# Access Compliance Report

### (Curb Ramps)

Intersection ID: 10243	Main Street: KARENDALE_AV	Cross Street: TUCKASEEGEE_RD	Location: NE
ADA ID: 223B1E776B35	Ramp Type: Perp	Initial Pass/Fail: Fail	Overall Compliance: No
		Severity Score: 1.25

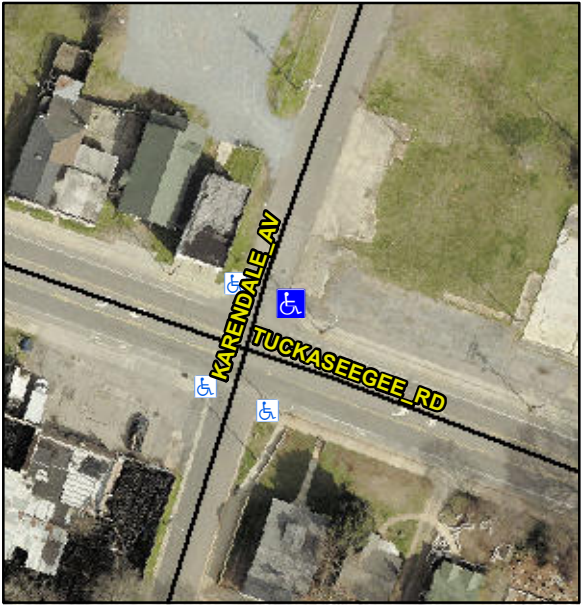
Codes/Mitigation Info/Possible Solution			Field Measurements/Component Compliance		
	Possible Solutions:		<b>Compliance</b>	<b>Description</b>	<b>Data</b>
	<b>Remove &amp; Replace Entire Ramp.</b>		<b>Yes</b>	Ramp Length (in)	72.0
			<b>No</b>	Ramp Width (in)	48.0
			<b>N/A</b>	Flare Type LT	N/A
			<b>N/A</b>	Flare Slope LT (%)	N/A
			<b>N/A</b>	Flare Traversable LT?	N/A
			<b>N/A</b>	Landing Length (in)	N/A
			<b>N/A</b>	Landing Width (in)	N/A
			<b>N/A</b>	Landing Slope (%)	N/A
			<b>N/A</b>	Landing X Slope (%)	N/A
<p>Surveyor Notes:</p> <p><b>N/A</b></p> <p>PROW/ADA:</p> <p><b>Not Found, R304.5.3</b></p>			<b>N/A</b>	Flare Type RT	N/A
			<b>N/A</b>	Flare Slope RT (%)	N/A
			<b>N/A</b>	Flare Traversable RT?	N/A
			<b>N/A</b>	DWS Provided?	N/A
			<b>N/A</b>	DWS Contrast?	N/A
			<b>N/A</b>	DWS Length (in)	N/A
			<b>N/A</b>	DWS Full Width?	N/A
			<b>N/A</b>	DWS Offset (in)	N/A
			<b>N/A</b>	Gutter Ponding?	N/A

<b>N/A</b>	Gutter Lip Ht (in)	N/A
			<b>No</b>	Painted X Walk1?	N/A
			<b>To W</b>	X Walk 1 Direction	N/A
			<b>N/A</b>	X Walk 1 Width (in)	N/A
			<b>5.0</b>	X Walk 1 Slope (%)	N/A
			<b>8.4</b>	X Walk 1 X Slope (%)	N/A
			<b>N/A</b>	Ramp inside XWalk1?	N/A
			<b>N/A</b>	Road Slope (%)	N/A
			<b>N/A</b>	Road X Slope (%)	N/A
			<b>N/A</b>	Any Obstructions?	N/A
				Obstruction Type	N/A
Total Cost:		\$ 1850.00	<b>N/A</b>	Clear Space?	N/A
			<b>N/A</b>	Clear Space to XWalk (in)	N/A
			<b>N/A</b>	Storm Grate/Utility Hazard?	N/A
				Storm Grate/Utility Type	N/A
			<b>Yes</b>	Surface Condition? (G/P)	Good
